NORTHRIDGE HEIGHTS

RE: S/D 99-79 -- Final Plat of NORTHRIDGE HEIGHTS ADDITION

RE: S/D 99-79 -- Final Plat of NORTHRIDGE HEIGHTS ADDITION

CASE NUMBER: S/D 99-79 -- NORTHRIDGE HEIGHTS ADDITION

NORTHRIDGE HEIGHTS

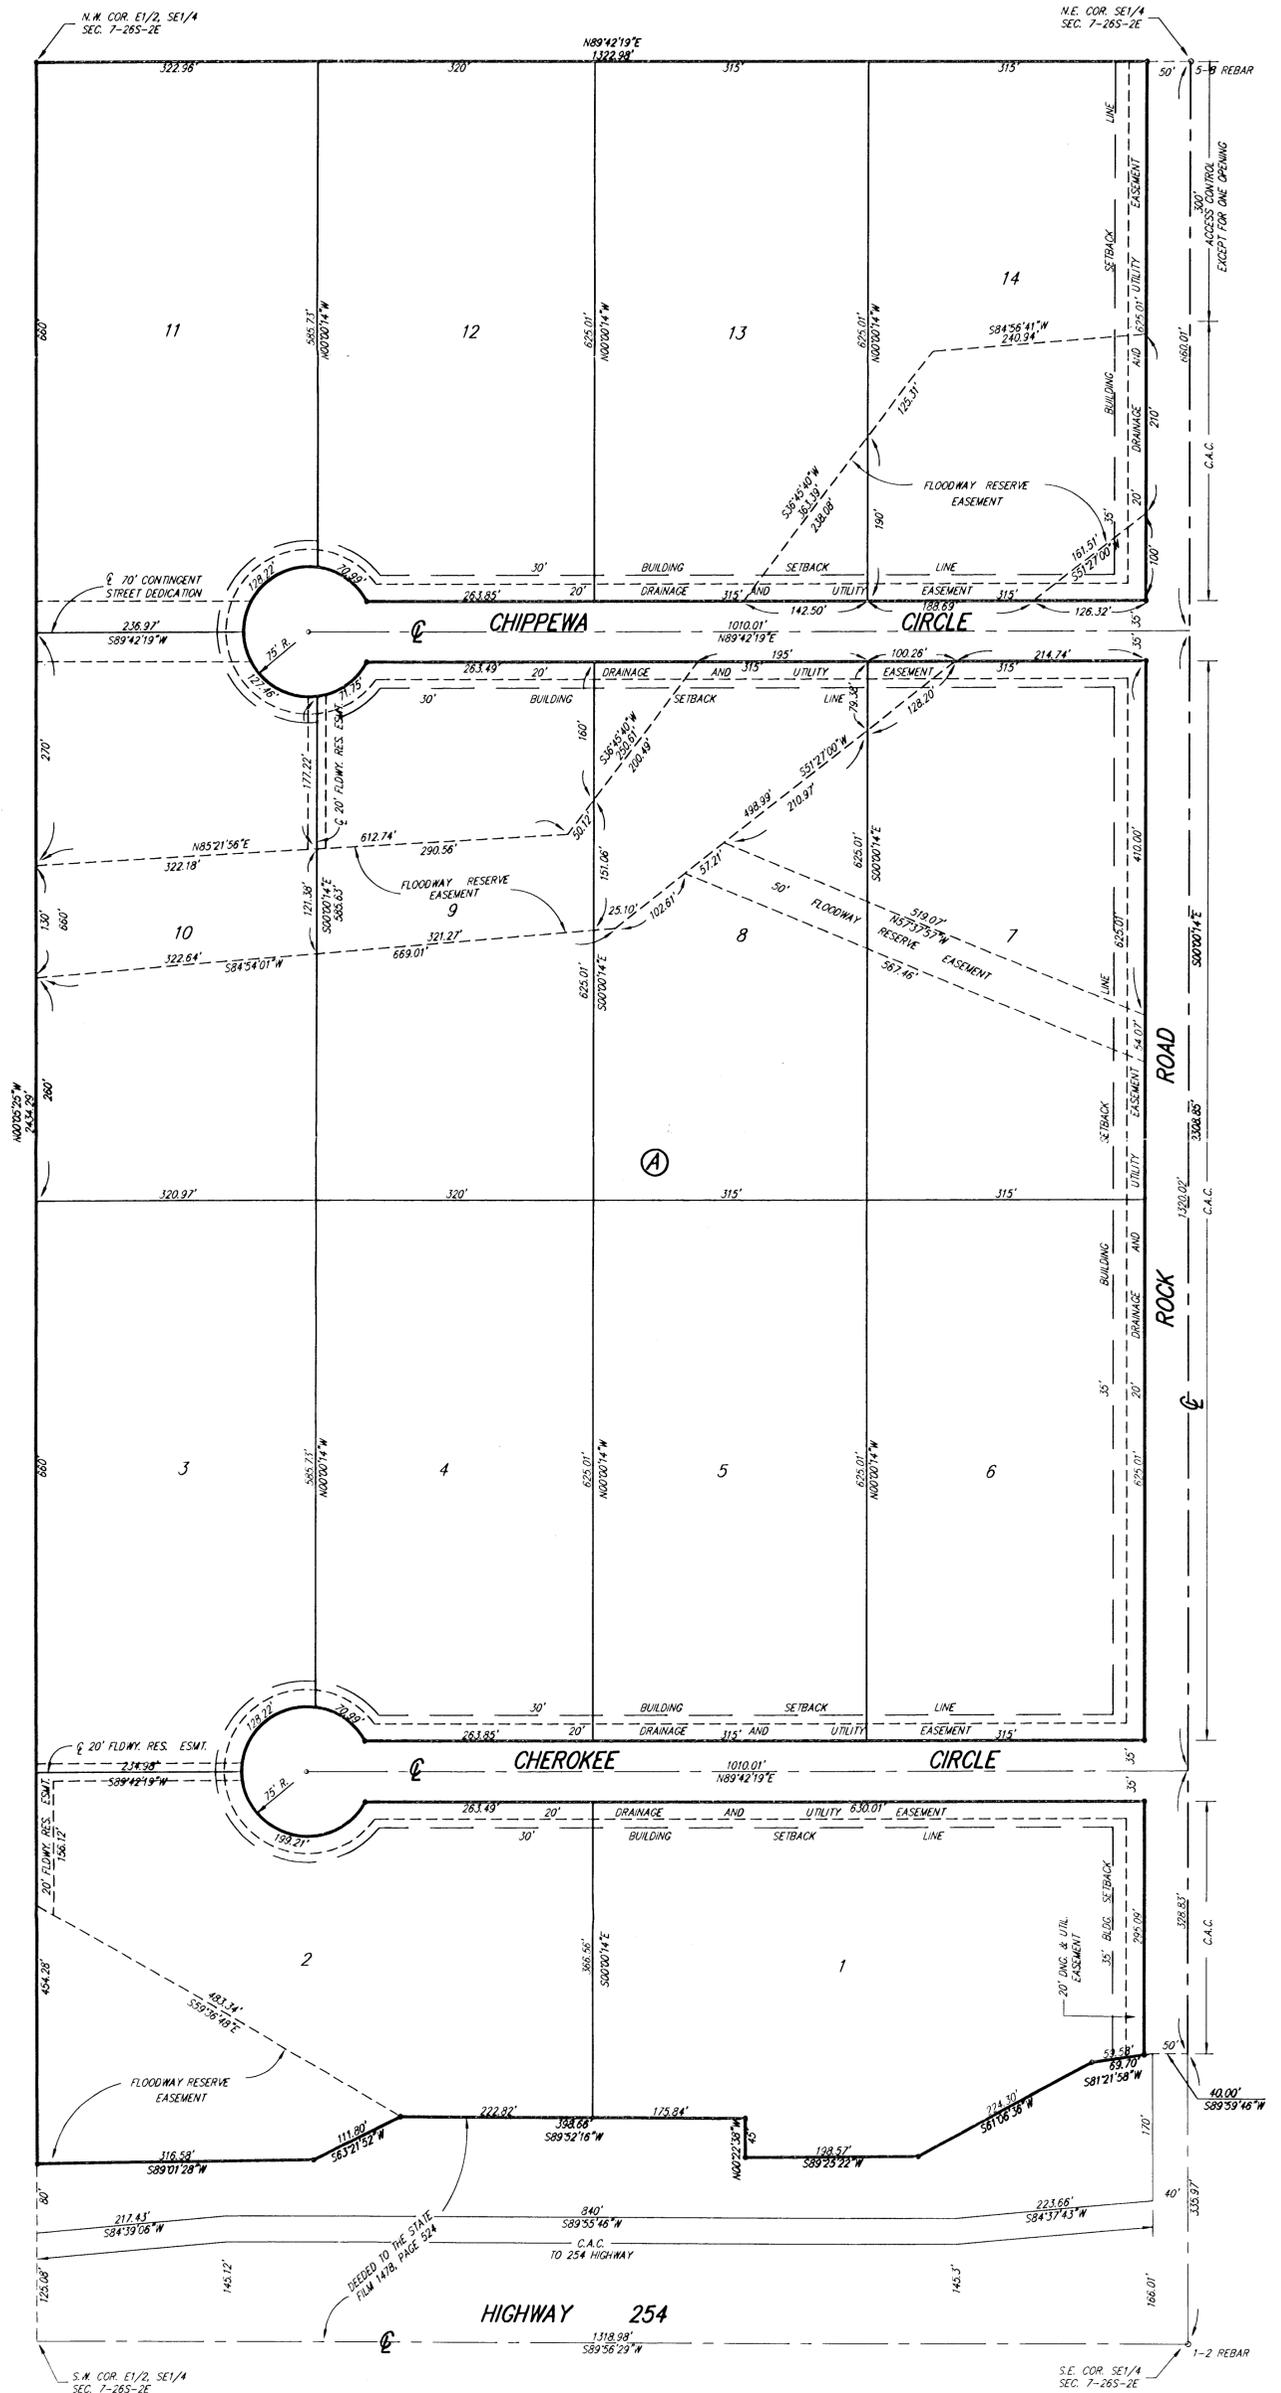
- D. **County Engineering** needs to comment on the status of the applicant's drainage plan. **The boundaries of the Floodway Reserves need to be revised. Drainage easements located at the northwest corner of Lot 2, Block A, and in Lots 7,8,9,10, Block A need to be denoted as Floodway Reserve easements. Minimum building pad should be referenced in the plattor's text. The location and elevation of benchmarks are required.**

- E. The MAPC certification shall be revised to reference "Northridge Heights".
- F. **County Engineering** should comment on the access controls. Complete access control has been dedicated along the site's frontage to K-254. One opening has been platted along Rock Road. **The access controls are approved.**

- I. County Fire needs to comment on the acceptability of the proposed street names. *The street names are acceptable.*
- J. A contingent dedication of right-of-way should be platted for Chippewa extending to the west line of the plat to provide potential street connection to the adjoining unplatted property.

- As requested, the right-of-way dedication has been platted.
- K. The platting text shall include language that a drainage plan has been developed for the plat and that all drainage easements, rights-of-way, or reserves shall remain at established grades or as modified with the approval of the applicable City or County Engineer, and unobstructed to allow for the conveyance of stormwater.
